Architect's Supplemental Instructions

PROJECT:
Summit Square
Apartments Phase II
 837 NW Donovan Road
 Lee's Summit, MO 64086

ARCHITECT'S SUPPLEMENTAL
INSTRUCTION NO.: 16

At the Owner's request, an addition to serve as the Parcel Storage room was added to Building 1. Additional revisions and clarifications to the scope are summarized per sheet, and reason for the change where applicable:

S2.12B

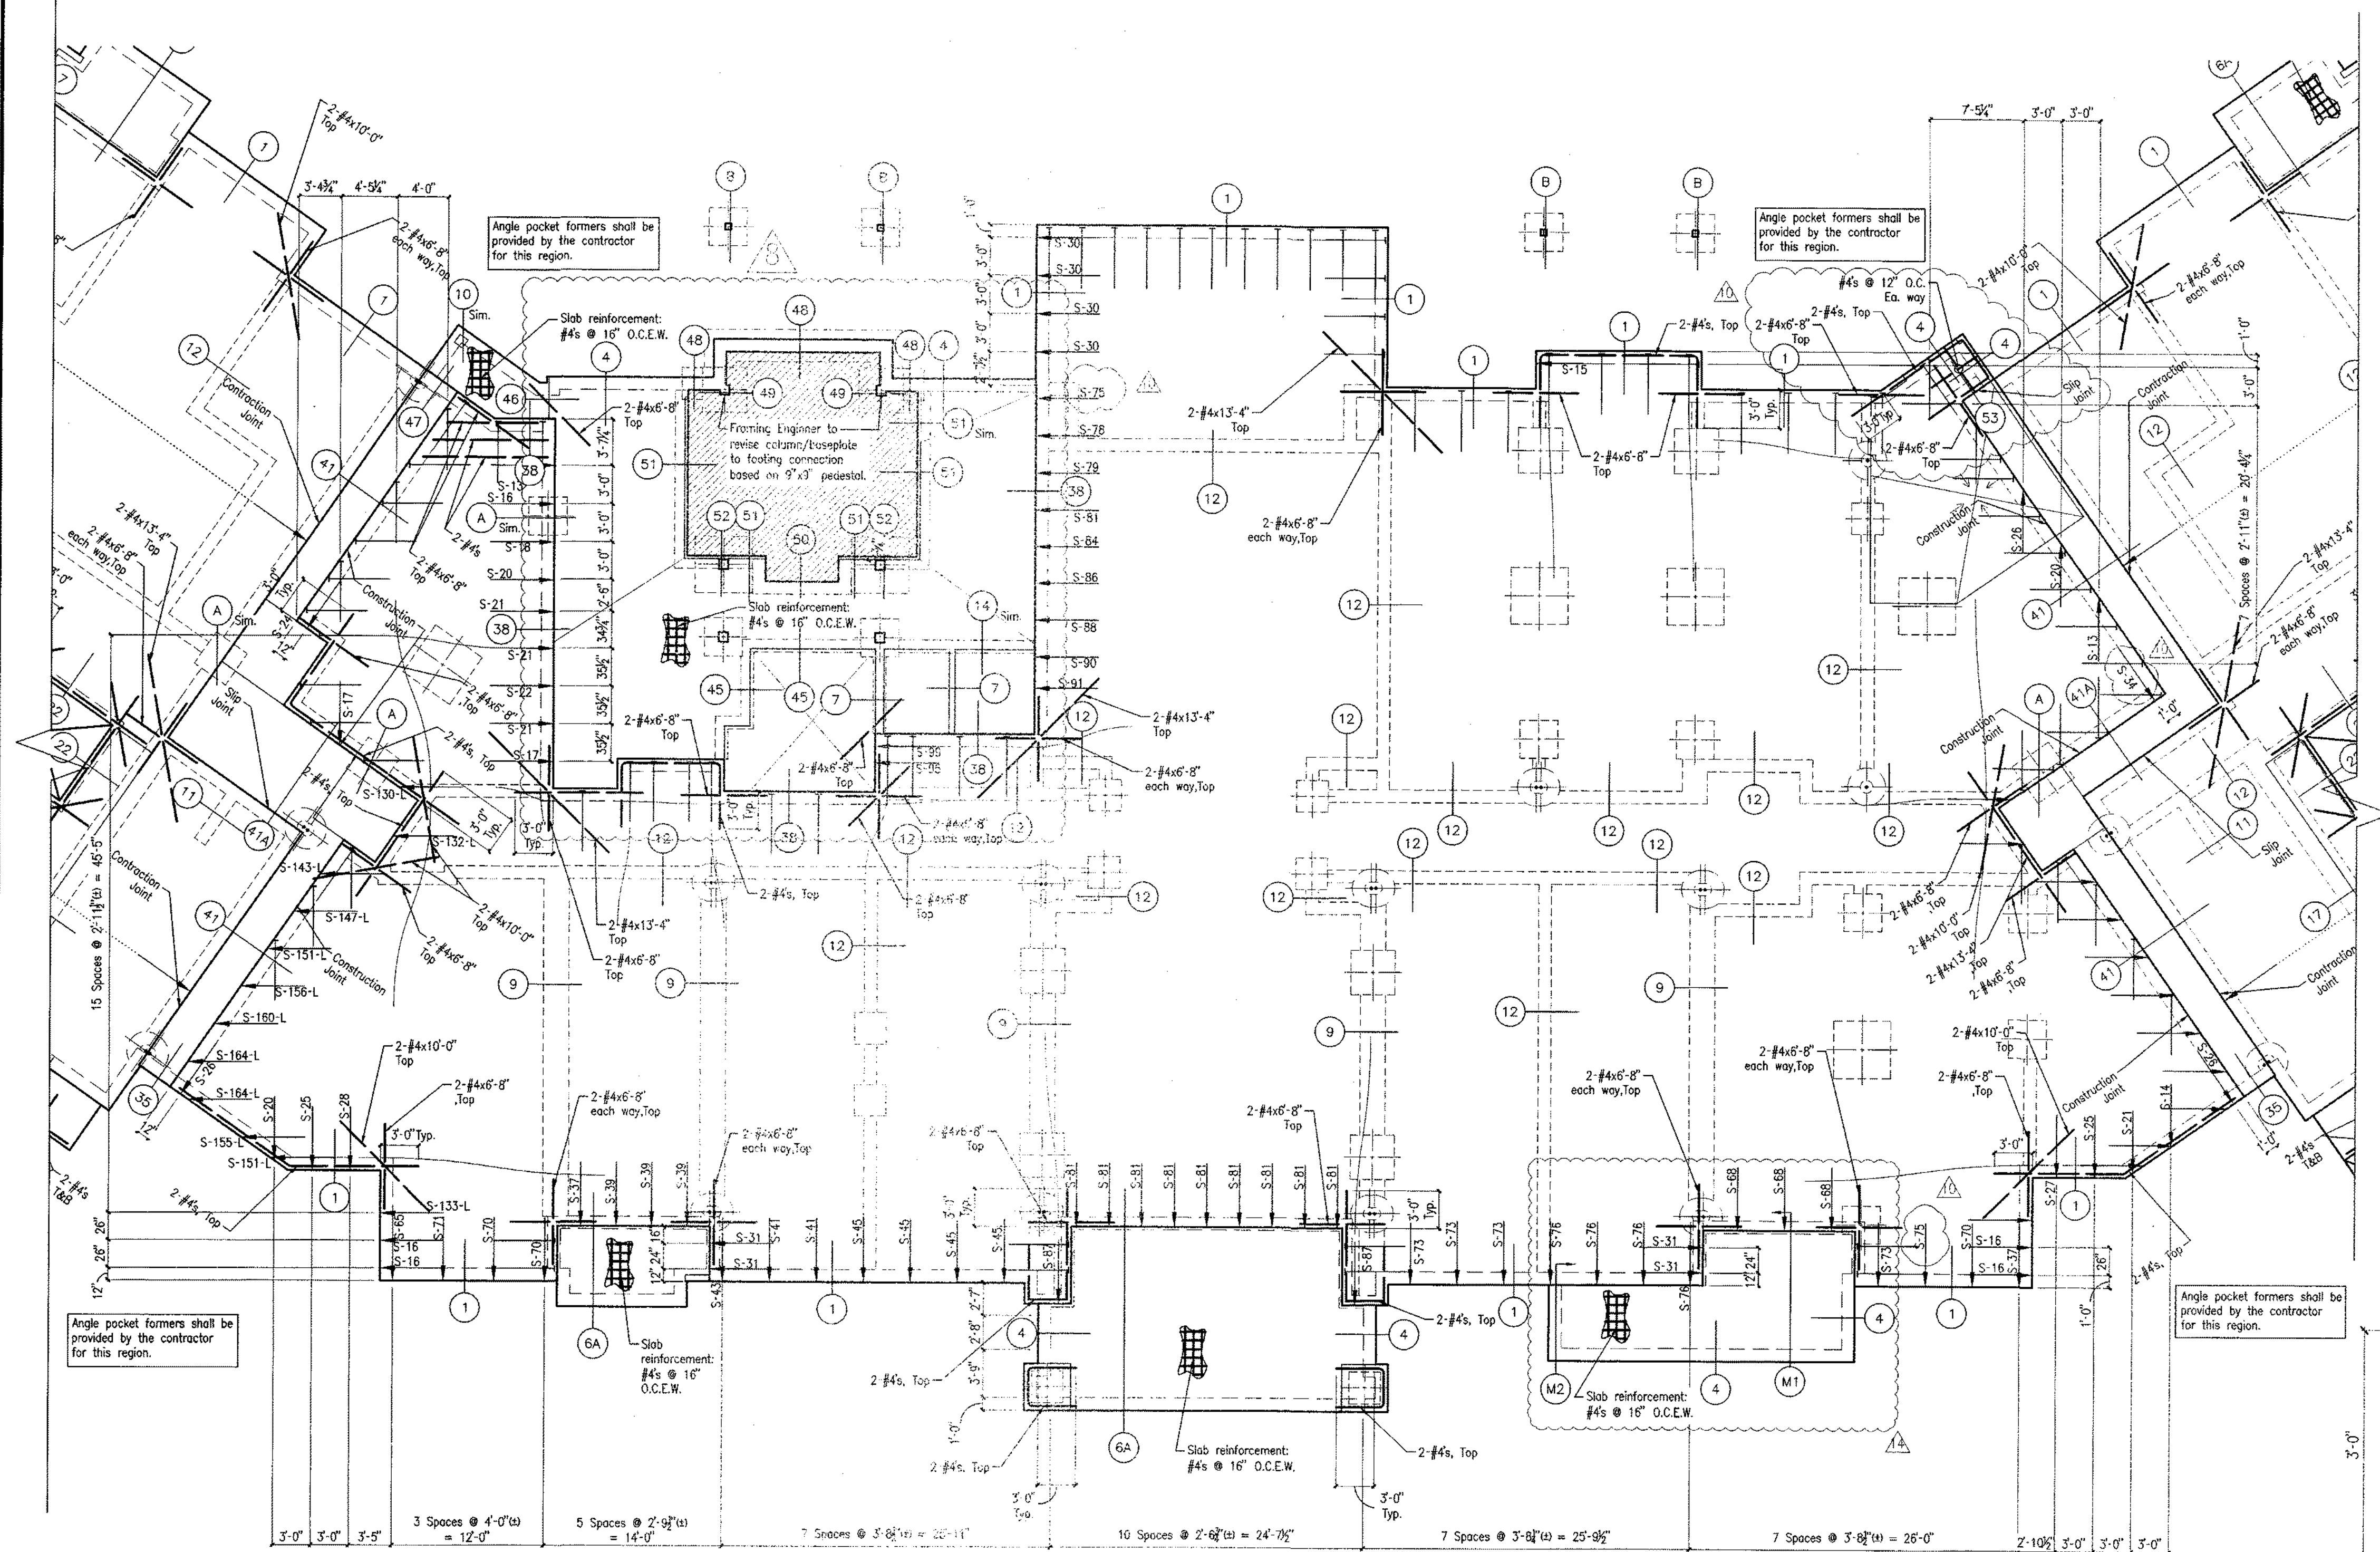
- S2.11B *Addition of Parcel Storage room and associated changes*
- S2.12B *Addition of Parcel Storage room and associated changes*
- S2.12C *Structural revisions (as previously indicated on TJI shop dwgs)*

FD-3.8

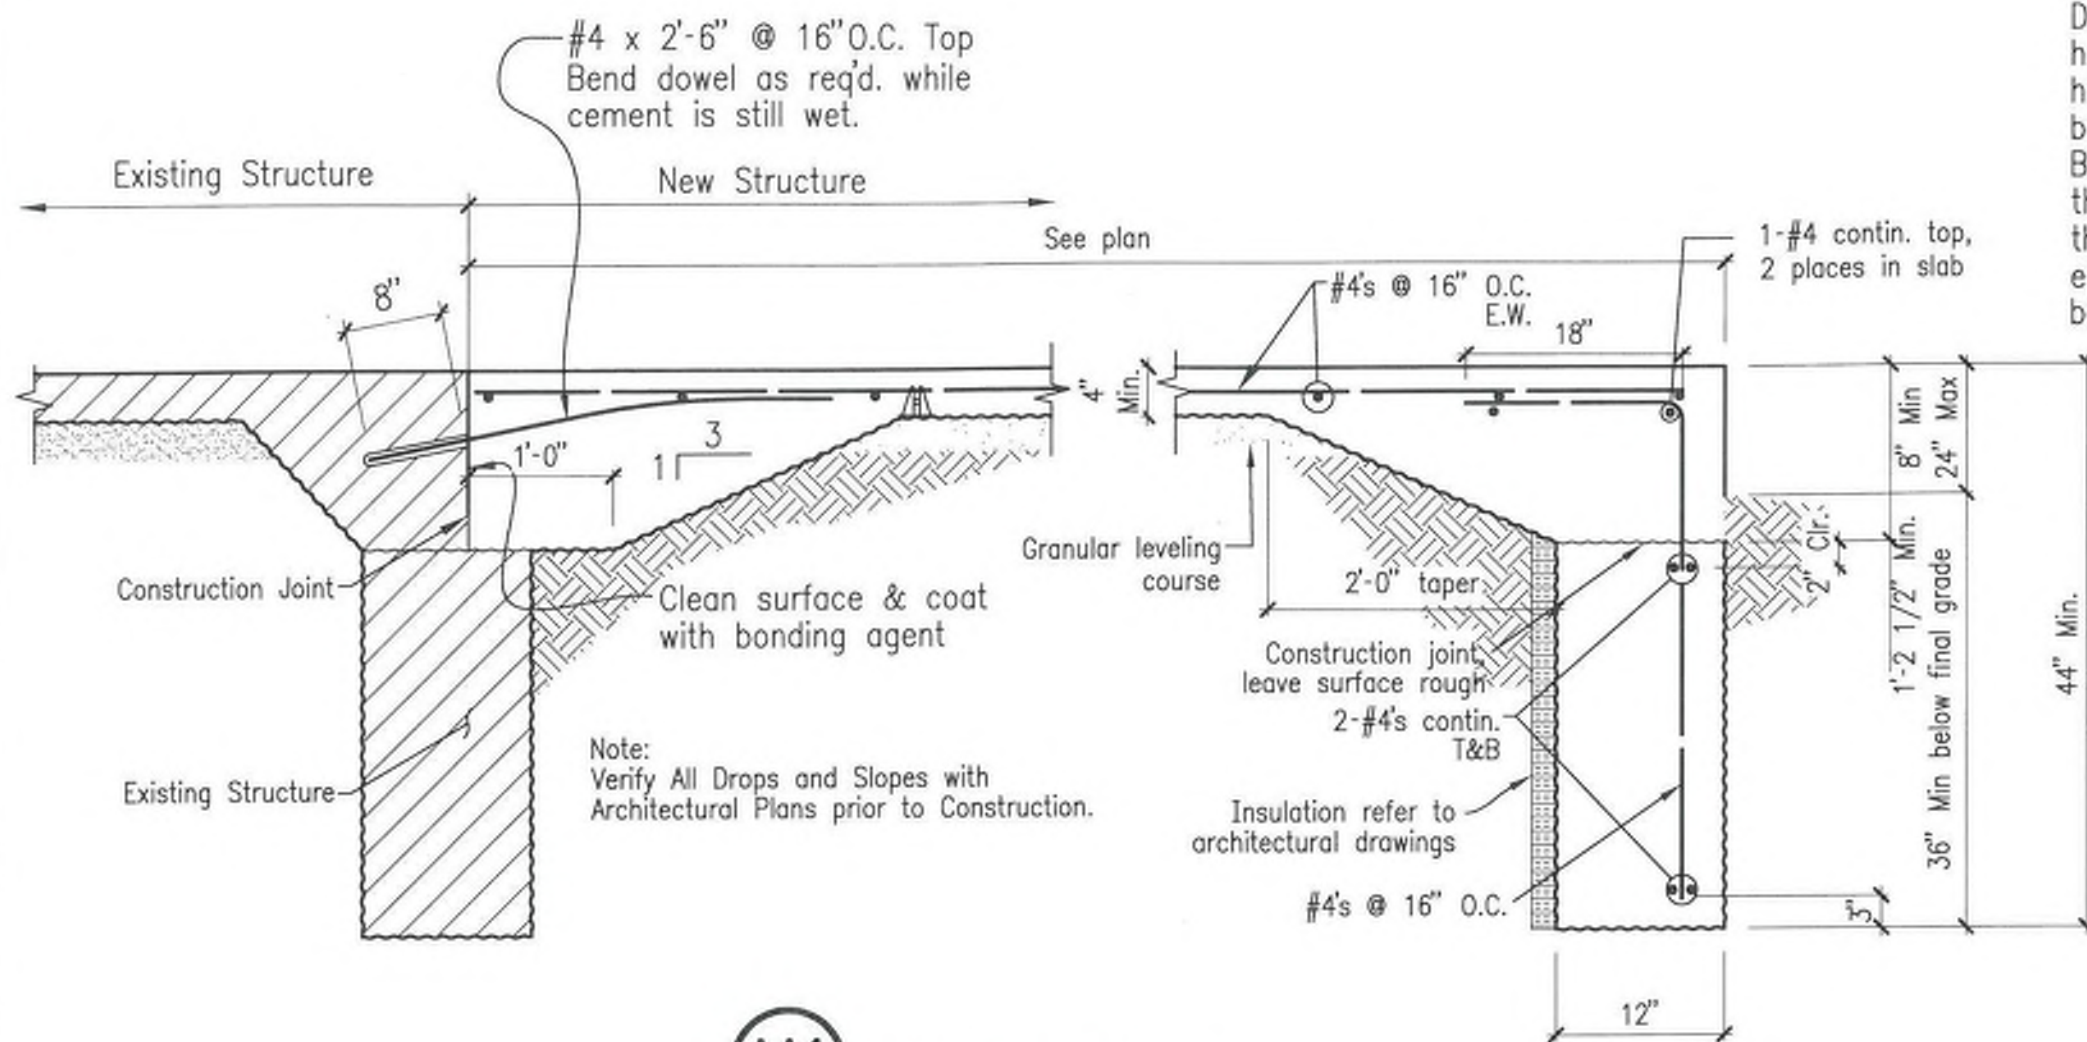
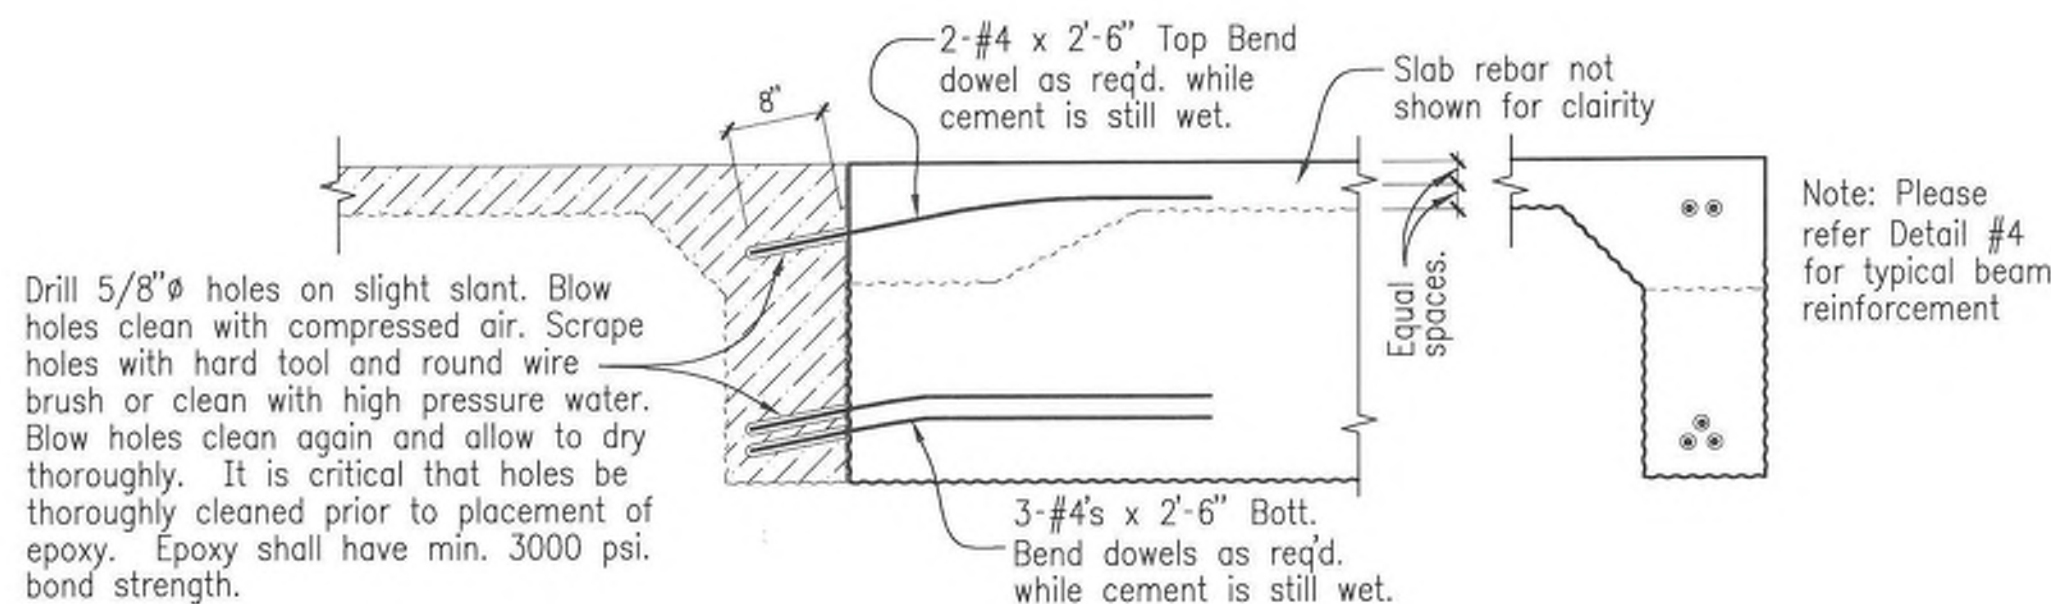
- FD-1.8 *Addition of Parcel Storage room and associated changes*
- FD-2.8 *Addition of Parcel Storage room and associated changes*
- FD-3.8 *Addition of Parcel Storage room and associated changes*
- Mail Room (8.5x11) – *Additional Details RE: Addition of Parcel Storage room*

Added Slab at Mail Room

DATE
08/10/2018
JOB NO.
614618
DRAWN BY:
CAD
SHEET NO.
E1.06a

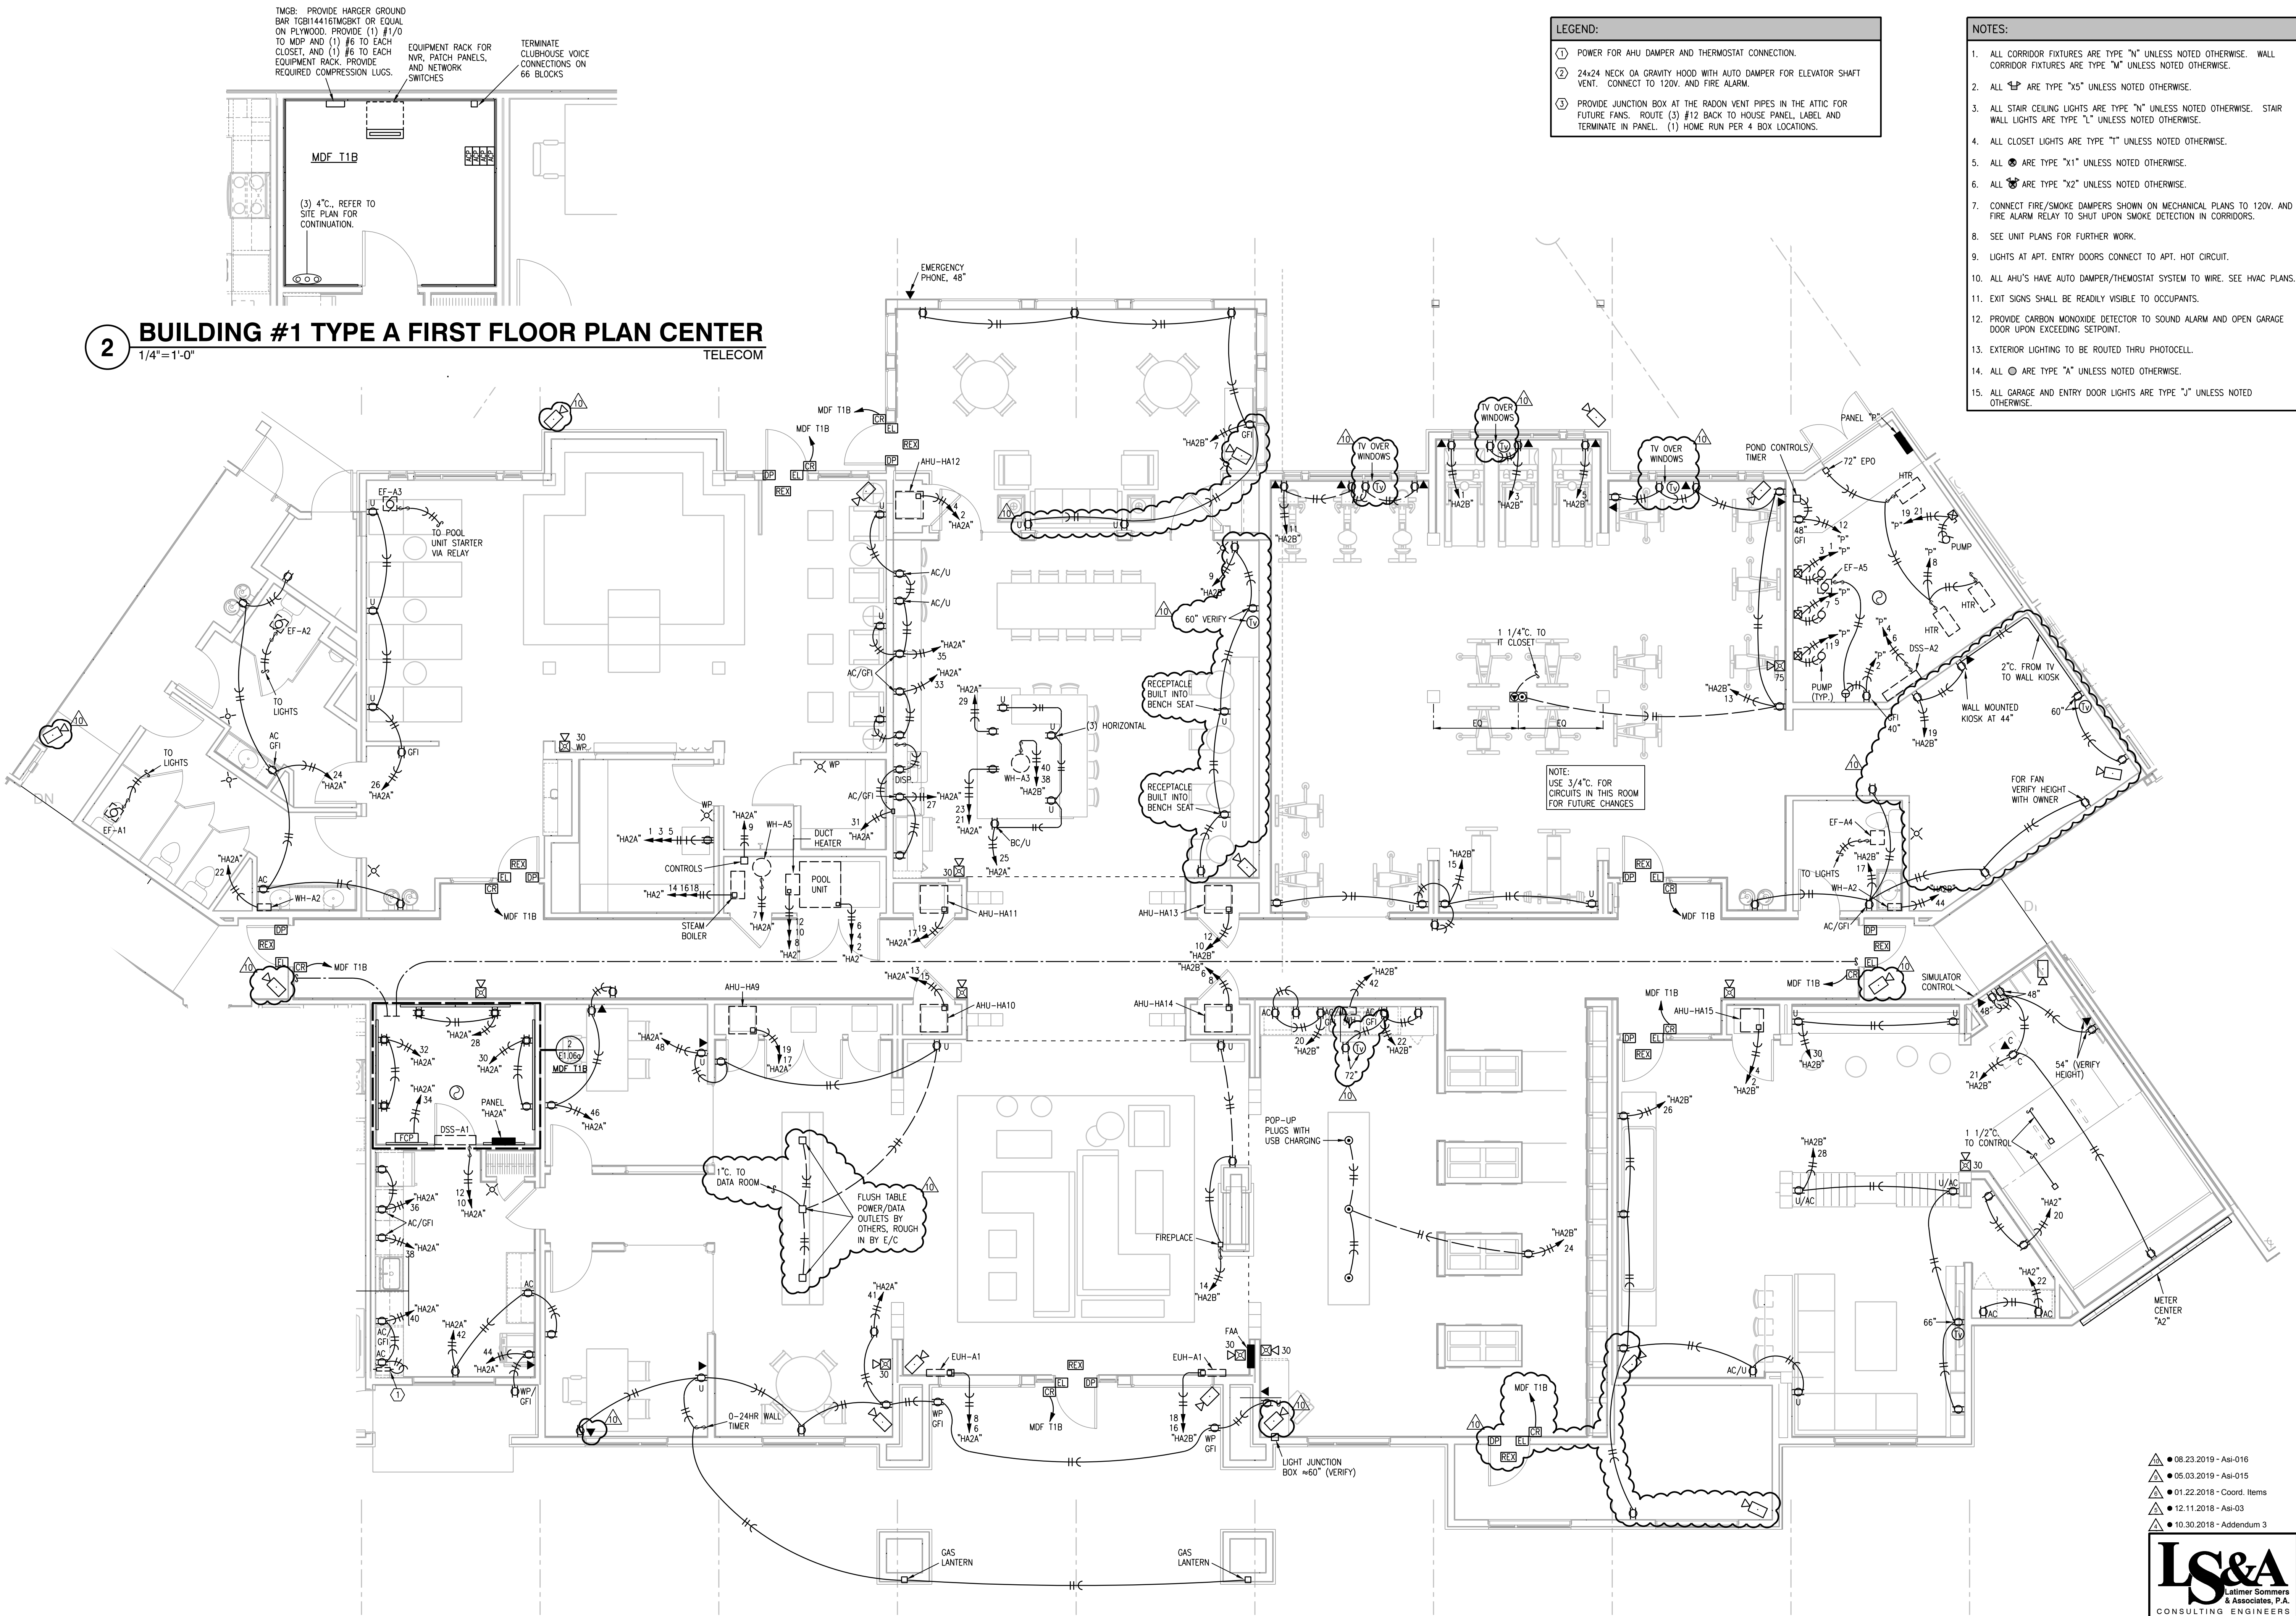
- ME1.02 *Misc. revisions*
- E1.06a *Misc. electrical revisions and additions*
- E1.06b *Misc. electrical revisions and additions*
- E1.07 *Misc. electrical revisions and additions*
- E2.04 *Misc. electrical revisions and additions*
- E2.05 *Misc. electrical revisions and additions*
- E4.05 *Update luminaire schedule per ID selected fixtures*
